| Panel Reference | 2018SCL035 |
| Proposed Development | Demolish existing structures and construct 'staged' development over three (3) sites. The proposal includes 357 apartments, a registered club with ancillary uses and a food and drink premises. A new through-site link connecting Regent Street to Fozzard Lane is also proposed. |
| Street Address | 3-7 & 13-17 Regent Street. 287-309 Trafalgar Street & 16-20 Fisher Street Petersham |

SUMMARY

Figure 1: Revised landscape plan showing landscaping to Regent Street frontage

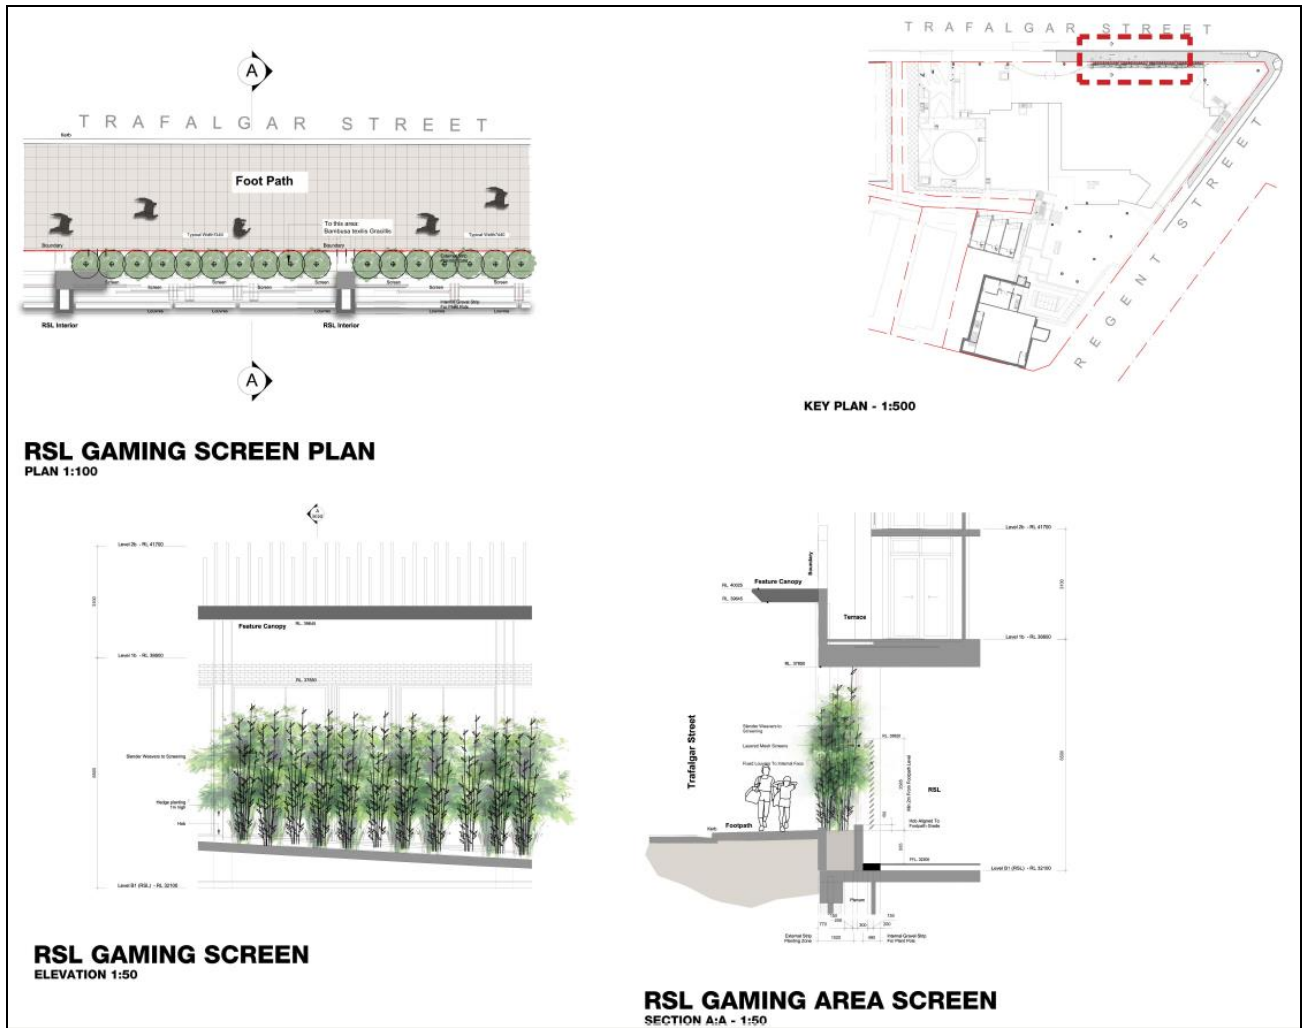
- 3. Amend the landscape plan for 'site 3' to provide landscape treatment along Trafalgar Street, to improve the overall streetscape appearance, including but necessarily limited to, the external face to the baffles to the outdoor gaming area. The minimum depth of any such landscaped area is to be no less than 1 metre.*

3. Amend the landscape plan for 'site 3' to provide landscape treatment along Trafalgar Street, to improve the overall streetscape appearance, including but necessarily limited to, the external face to the baffles to the outdoor gaming area. The minimum depth of any such landscaped area is to be no less than 1 metre.

Amended plans were submitted to Council which show the landscape treatment along Trafalgar Street (see Figure 1). The landscape treatment has a depth of 1.25m (inclusive of the planter boxes), is confined to the area in front of the baffles to the outdoor gaming area and includes a variety of bamboo. It is considered that the landscape treatment will improve the overall streetscape appearance. The amended landscaped plans have been included in a separate attachment (**Attachment 3**).

It is considered that the amended plans satisfy the resolution of the SECPP.

Regarding resolution 3. concerning the amended landscape plan, Council officers are of the opinion that this resolution has been satisfied.

Figure 2: Revised RSL ground floor plan for Site 3.

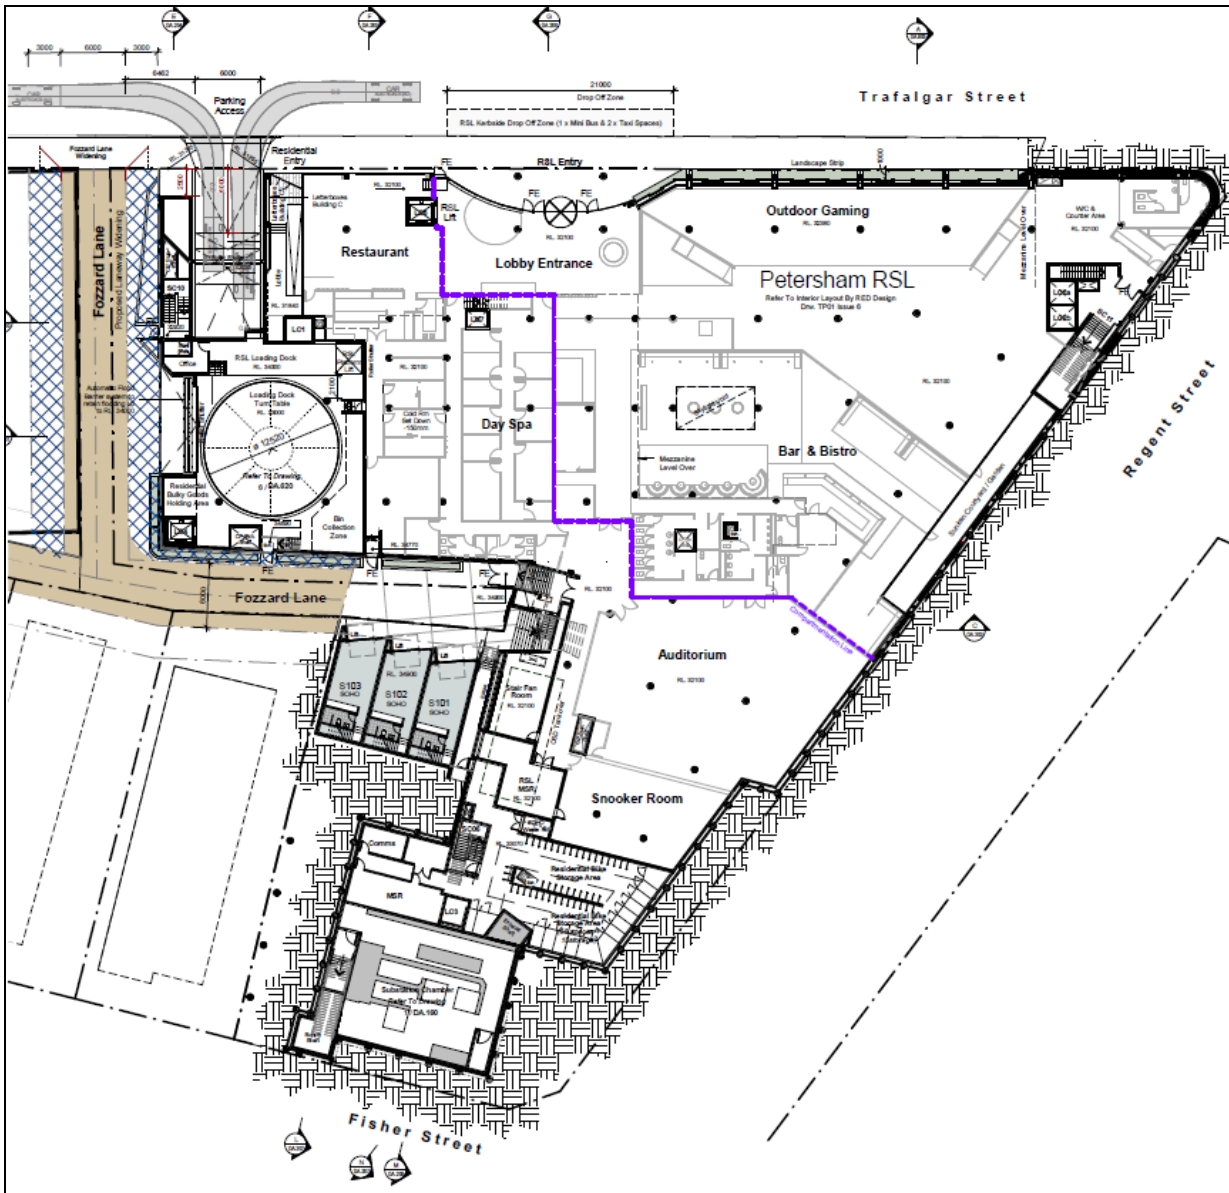
- 4. Amend plan DA.099K "plan Level B1 – Ground Floor RSL" prepared by Nordon Jago Architects dated 4 April 2019 to be consistent with plan TP01 issue 6 "Proposed Ground Floor Plan" prepared by Red Design Group dated 13 November 2017.*

4. Amend plan DA.099K "plan Level B1 – Ground Floor RSL" prepared by Nordon Jago Architects dated 4 April 2019 to be consistent with plan TP01 issue 6 "Proposed Ground Floor Plan" prepared by Red Design Group dated 13 November 2017.

An amended plan was submitted to Council which resolved the previous inconsistencies in the two plans (see Figure 2). The amended plan has been included in a separate attachment (**Attachment 4**).

Regarding resolution 4. concerning inconsistencies in the ground floor plans of Site 3, Council officers are of the opinion that this resolution has been satisfied.
